La Vista City Centre

CITY OF LA VISTA
PLANNING DIVISION

RECOMMENDATION REPORT

CASE NUMBER: 2016-SUB-04

0' 40' 80' 160'
 SCALE IN FEET

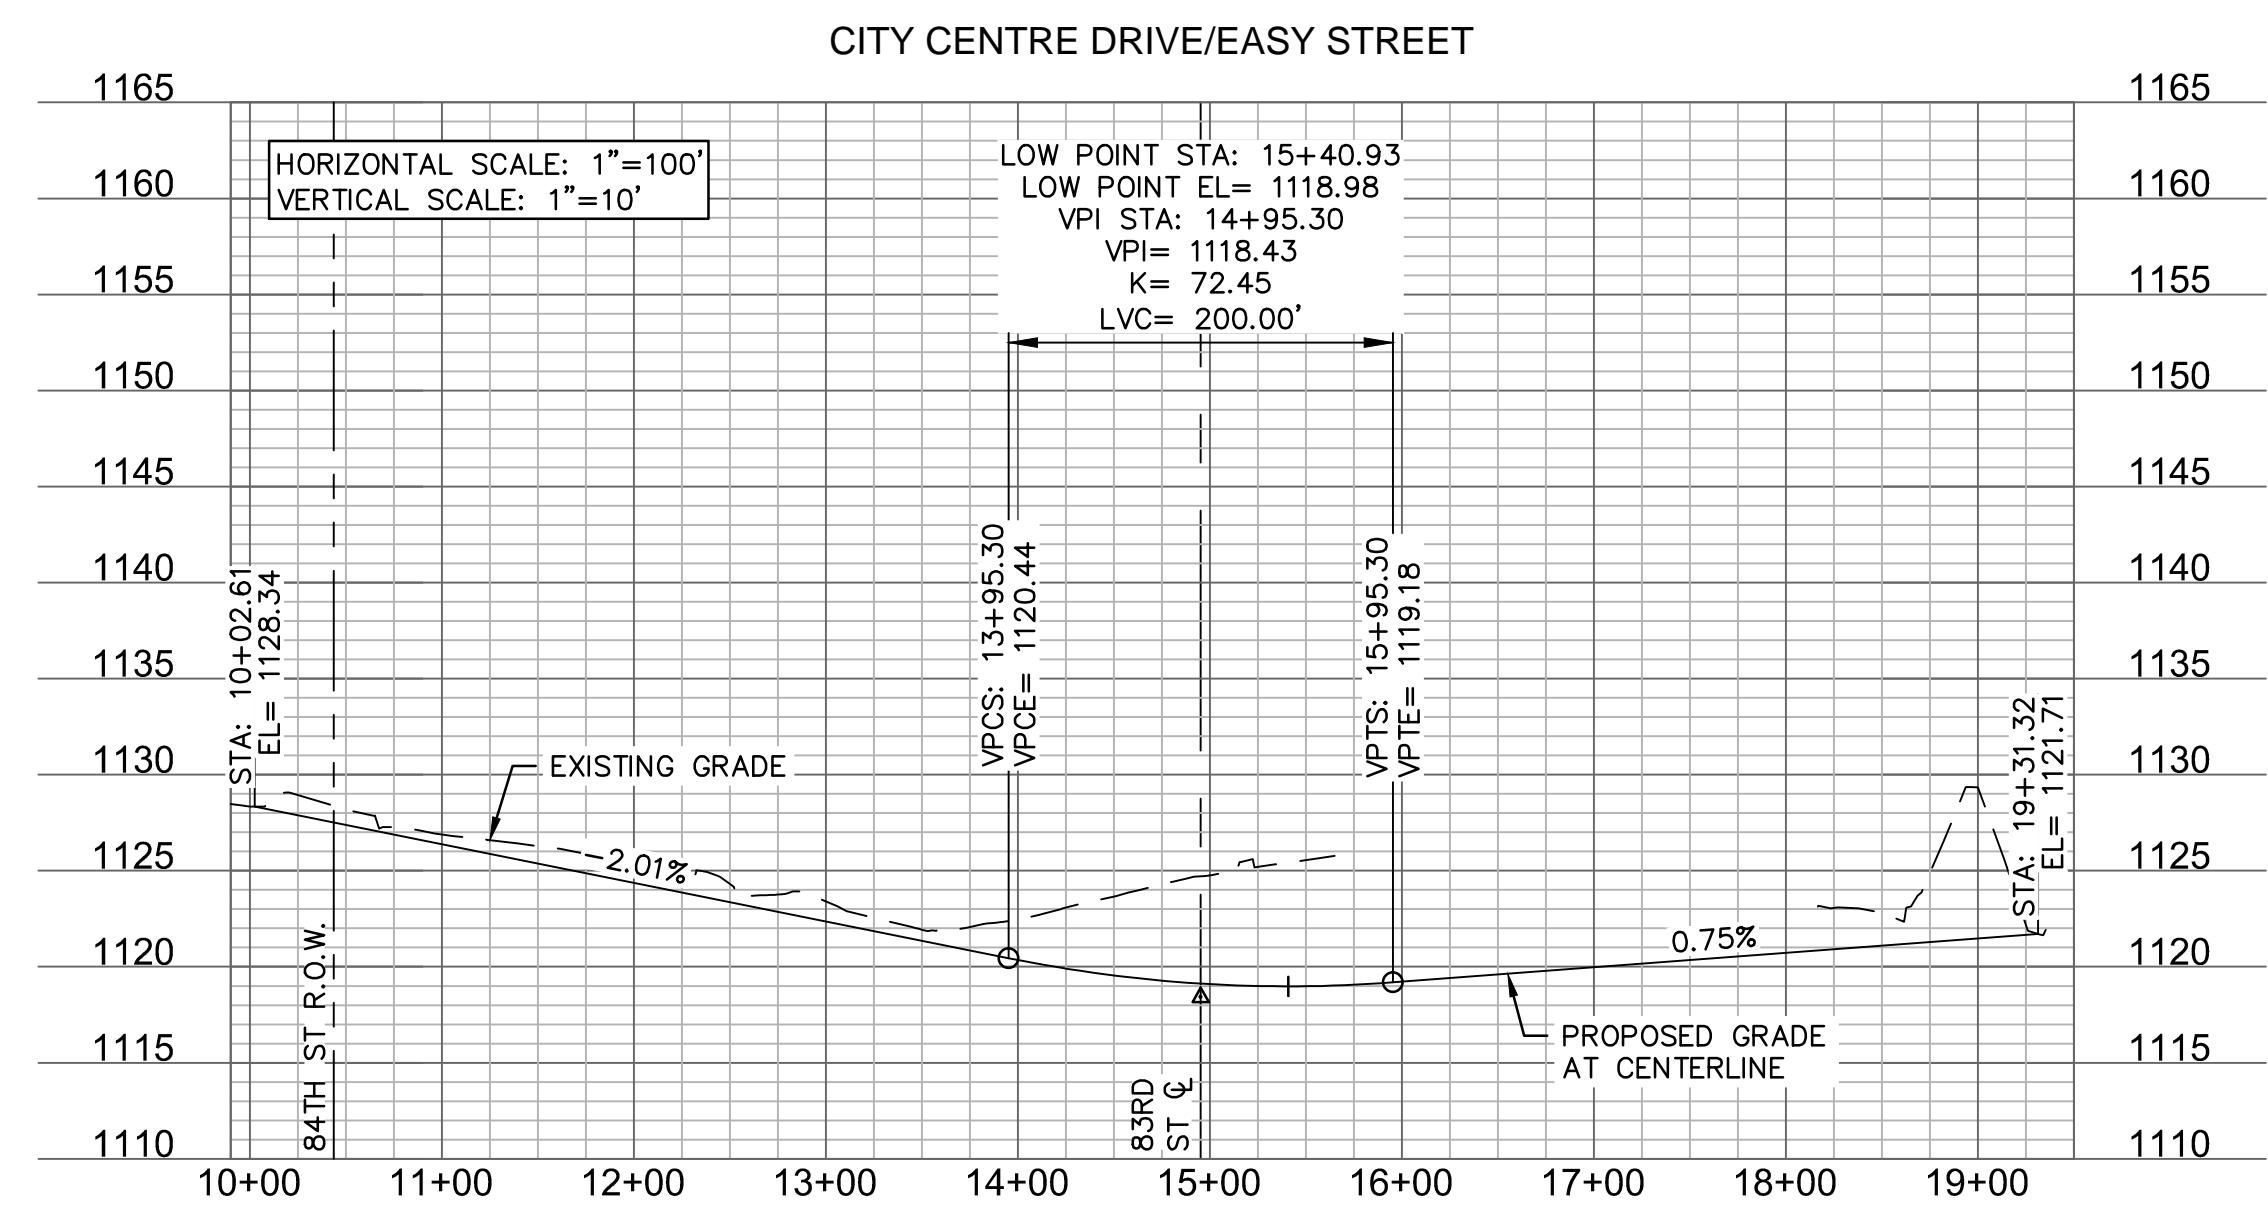
2. On Sheet C3.2 there needs to be a note added stating that a single grading and erosion control permit will be obtained for all lots in the preliminary plat. The fewest number of grading permits is preferred to allow for ease of administration and coordination of inspections as well as reducing permit costs for the applicant.

Response: Note has been added to the plan
